RE: PP-2022-3016 – 1377 Hue Hue Road, Wyee – Revised flood information

Orion has reviewed the recommendations issued by the Biodiversity and Conservation Division letter sent 7th March 2024 (letter in Attachment C), and the 27/03/2024 email comments (attachment C) we provide the following responses:

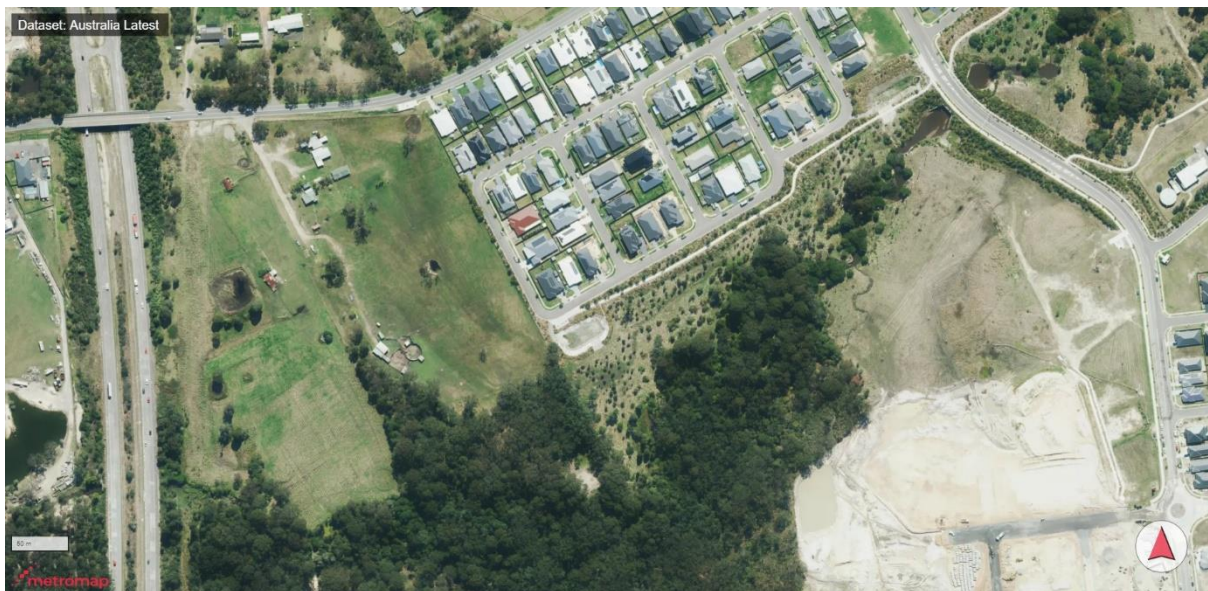
Recommendation No 1:

The report must clearly specify what FPL is proposed for the site. The rezoning boundary must be located above this level.

The Flood Planning Level proposed for the site is the 1 in 100-year flood level. The 100-year flood level is shown on the following Flood Planning Level Map added to our revised report.

As per section 2.9 of DCP 2014 Part 8 Subdivision development, the new lots are located above the Defined Flood Event which is the 100-year flood level (also referenced as the 1% AEP Storm event) as shown on Figures 6 and 7 on page 25 and discussed on pages 26 and 27. The 1 in 100 year is our defined flood event. The rezoning boundary will be located above the flood planning level. Note that no development lots are proposed south of Road 3.

Note that the flood modelling is based on the existing site levels. The detailed design of the subdivision will include raising road 3 and Lots 45, 46 and 47 to be above 25.8m RL to be above the proposed basin crest and to connect to the existing Jarvis Street to the east and to Digary Road to the West

The proposed lots are to be outside the footprint of the 1 in 100-year flood extent. As per the Flood Planning Level Map, the adjacent Flood levels of 24.80 m RL in the west to 23.75 m RL in the east.

Subdivision Layout overlaid on survey.

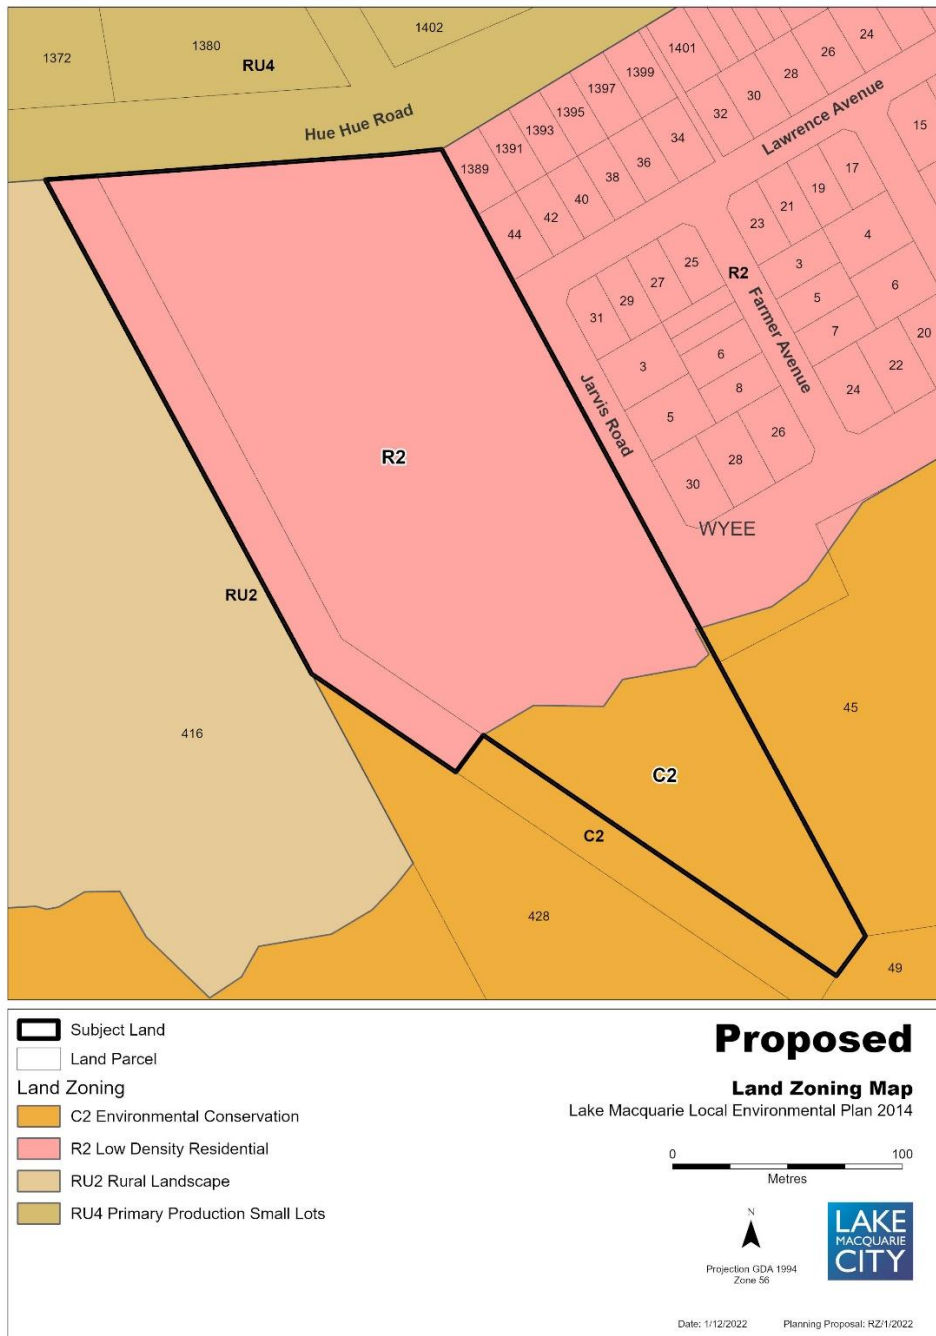
Recommendation 2

Mapping presented in the report should be updated to show the correct subdivision layout.

The subdivision layout in Appendix C of the integrated water management and flood report has been updated to show the current layout. A link to the updated report is provided in Appendix A of this response letter.

Figure 1 General flood hazard vulnerability curve

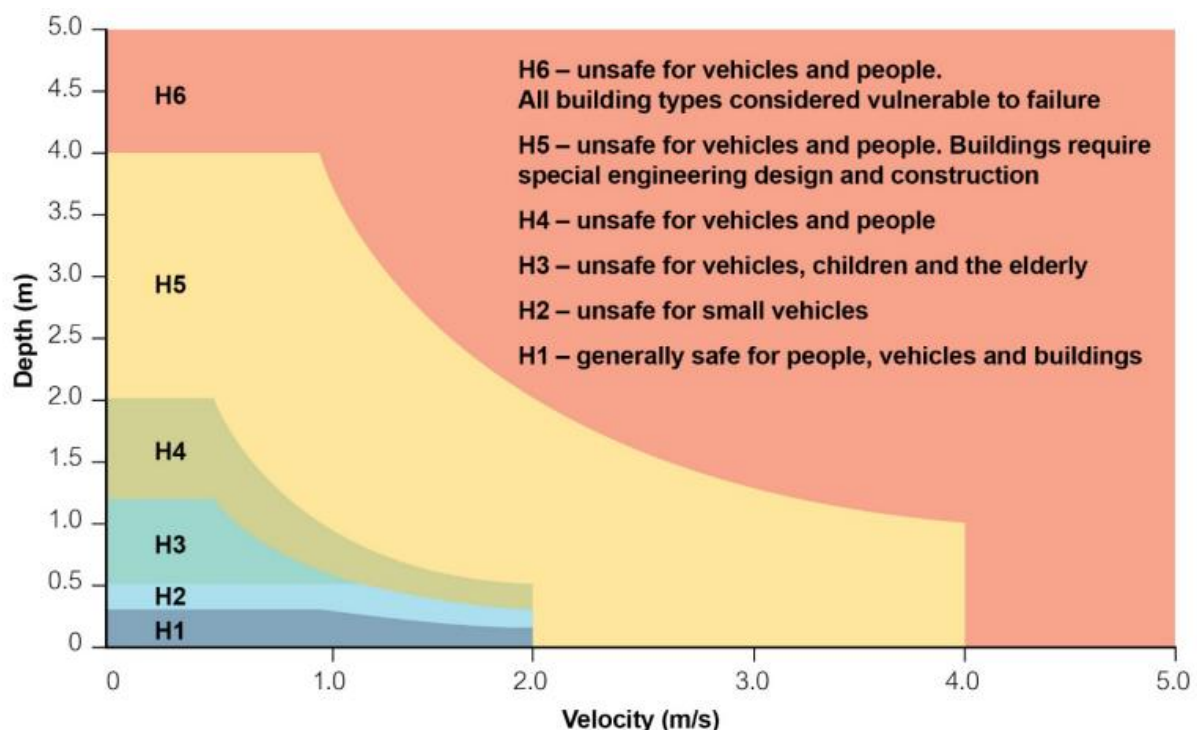
Recommendation 3

Post-development flood modelling is required to understand flood hazard and emergency response requirements during the PMF event.

We believe the existing analysis provides a good understanding of the flood hazard and emergency response requirements for the PMF Flood event.

The flood modelling shows the minimal extent of PMF flood depth and velocity impact for the subdivision for lots 45, 46 and 47.

The modelling shows the current PMF depth is less than 200mm and the velocity less than 1.0m/s.

This gives a depth velocity figure of 0.2, which is in the H1 Flood Hazard zone for the PMF flood event which is generally safe for people vehicles and buildings as per the Hazard Category figure below from DPE's Flood risk management guideline FB03.

Figure 1: PMF Event Depth Map

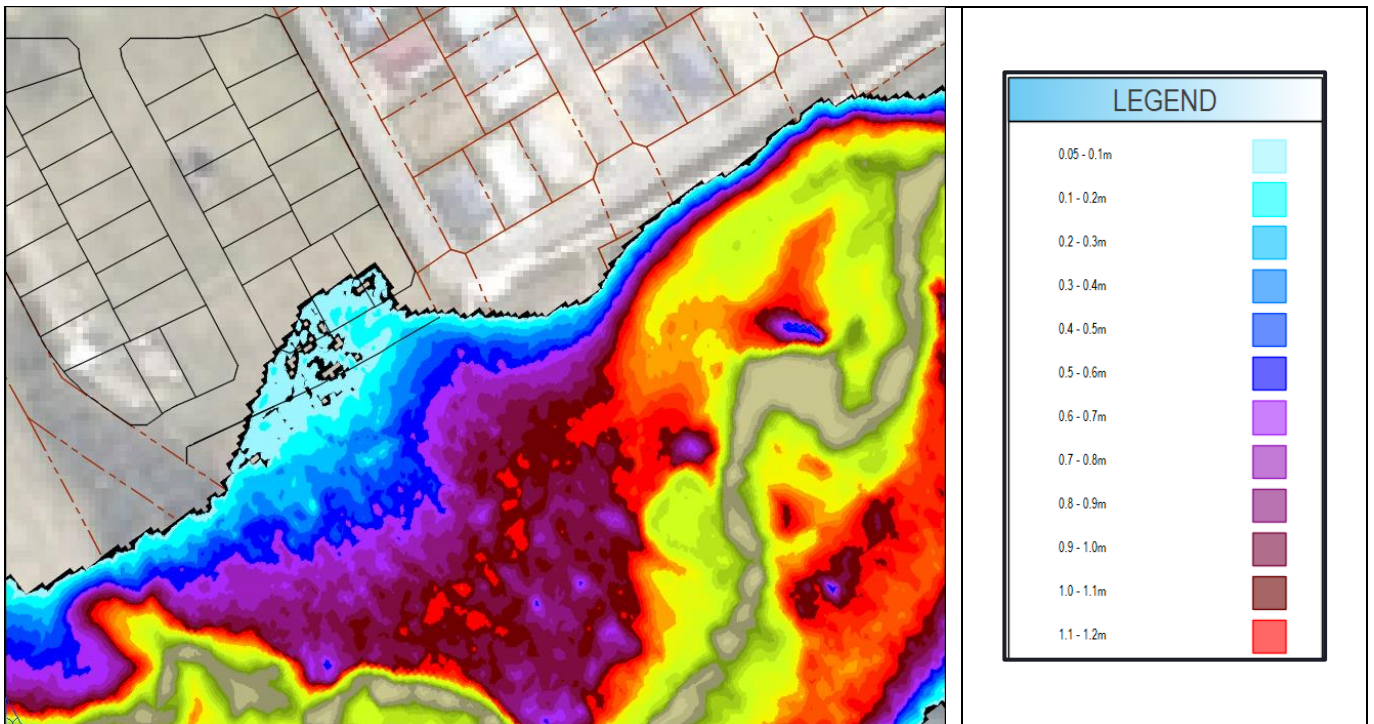
- *The PMF mapping referenced in the cover letter (22/03/24) is not consistent with the mapping included in the previous technical memo (18/05/22) – see screenshots below. It looks like the cover letter is referencing the Manning's roughness sensitivity result which has lower flood depths and velocities than the baseline run. The commentary under "Recommendation 3" in the cover letter needs to be updated to reflect the correct model results.*

In response to this comment Orion was asked via BCD comments to use the manning's n values which were consistent with the WMAwater report as discussed on pages 19 to 23 of the IWC management report – refer to the link in Attachment A. The results as quoted in figures 1 and 2 of the Recommendation 3 response are consistent with the WMAwater manning's values rather than the values used in the 18/05/22. The results used are the most recent corrected results.

Figure 1: PMF Event Depth Map

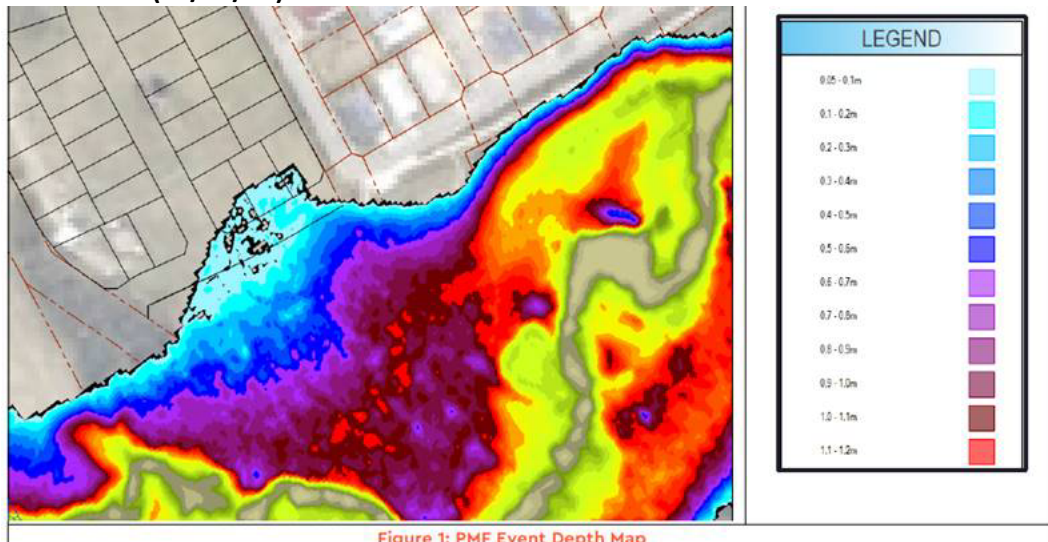
- The PMF mapping referenced in the cover letter (22/03/24) is not consistent with the mapping included in the previous technical memo (18/05/22) – see screenshots below. It looks like the cover letter is referencing the Manning's roughness sensitivity result which has lower flood depths and velocities than the baseline run. The commentary under "Recommendation 3" in the cover letter needs to be updated to reflect the correct model results.
- The colours shown on the hazard maps in the Integrated Water Management Report don't align with what's on the legend. I assume the post-processing of results is correct and it is just the colours that don't match up, but probably worth confirming with the consultant.
